SUBJECT: Forwards replacement pages for HPI reliability rept Pages  
5-56 & 5-57, which was forwarded to NRC on 971218.

Subject: Oconee Nuclear Station  
Docket Nos. 50-269, -270, -287  
High Pressure Injection (HPI) Reliability Study

Attached are replacement pages for HPI Reliability Report  
pages 5-56 and 5-57 (pages 2 of 3 and 3 of 3 of Figure 5.3-  
1) which was forwarded to you on December 18, 1997. During  
the printing process, plots from Figures 5.3-2 were  
inadvertently used in Figure 5.3-1 also.

Figure 5.3-1 Uncertainty Analysis Summary For DBA LOCA, Injection Mode

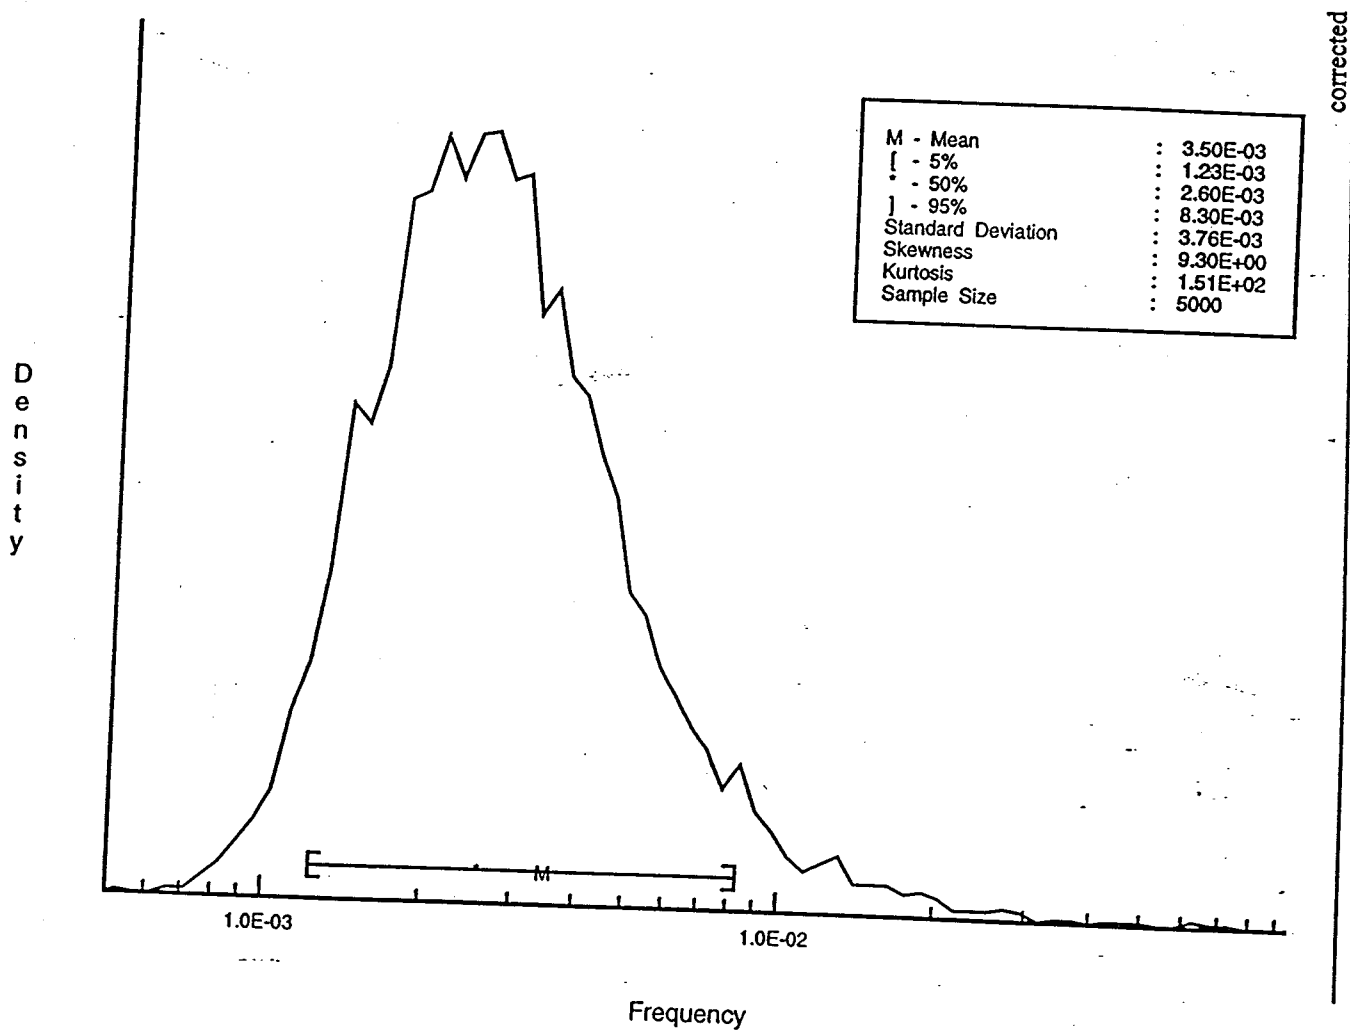
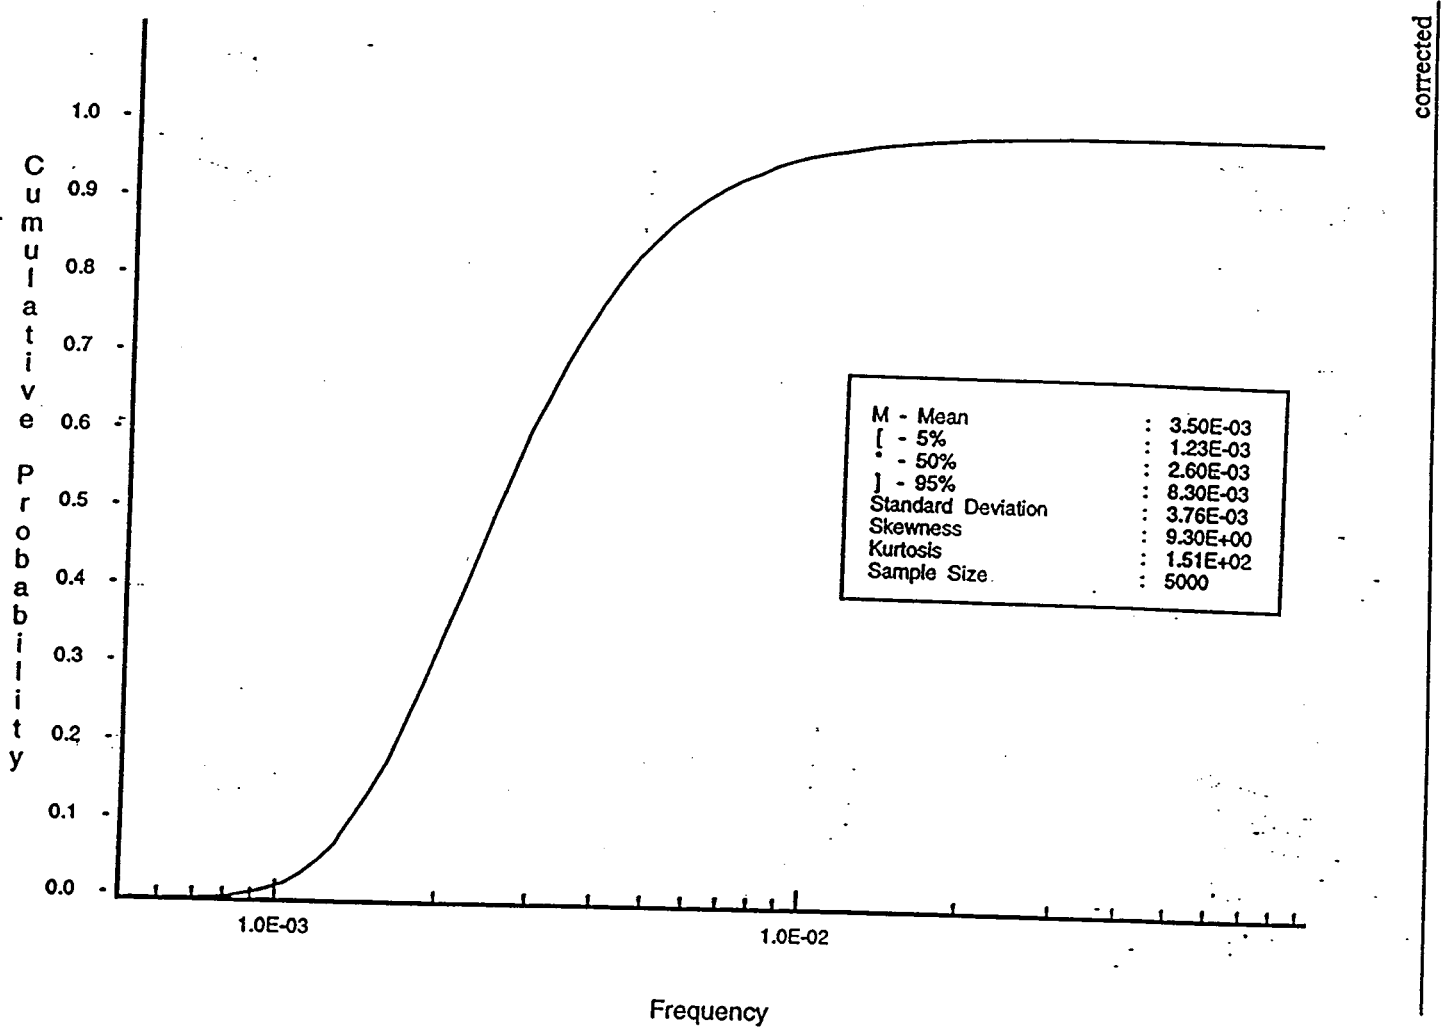
Please replace pages 5-56 and 5-57 in your copy of the  
report. We apologize for this inconvenience.
